No.	Description	Date	By
0	APPROVAL PRINT	3-6-13	TRH

Project: HANCOCK ER BRF 0174
HANCOCK, VT

Drawing: DECK CLOSURE REINFORCEMENT

ABUTMENT #1 CLOSURE POUR

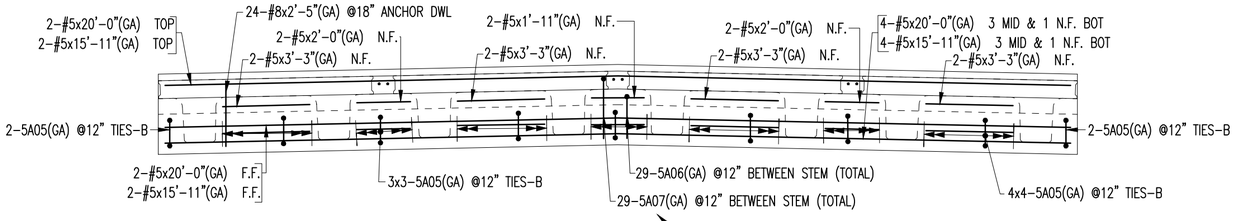
PER PRECAST DWG F3 THE BACK WALL WIDTH IS 9" WHICH WITH 3" COVER WOULD MAKE "U" CENTER BEND 3" WHICH WE CAN'T BEND 6" IS THE TIGHTEST IS THIS OK? BARS COULD BE TWISTED TO ACHIEVE COVER PLEASE VERIFY

ABUTMENT #2 CLOSURE POUR

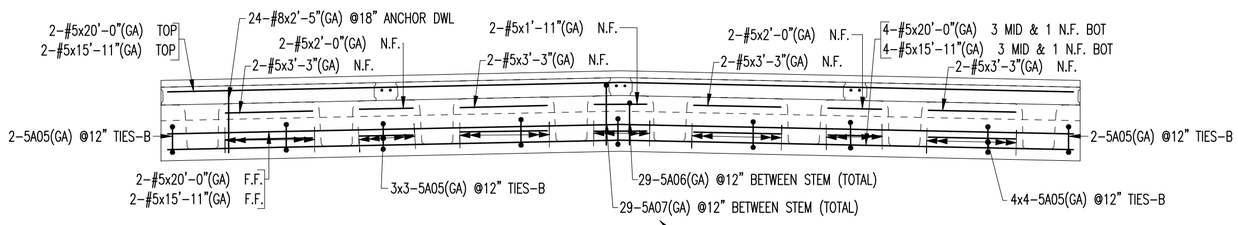
PER PRECAST DWG F3 THE BACK WALL WIDTH IS 9" WHICH WITH 3" COVER WOULD MAKE "U" CENTER BEND 3" WHICH WE CAN'T BEND 6" IS THE TIGHTEST IS THIS OK? BARS COULD BE TWISTED TO ACHIEVE COVER PLEASE VERIFY
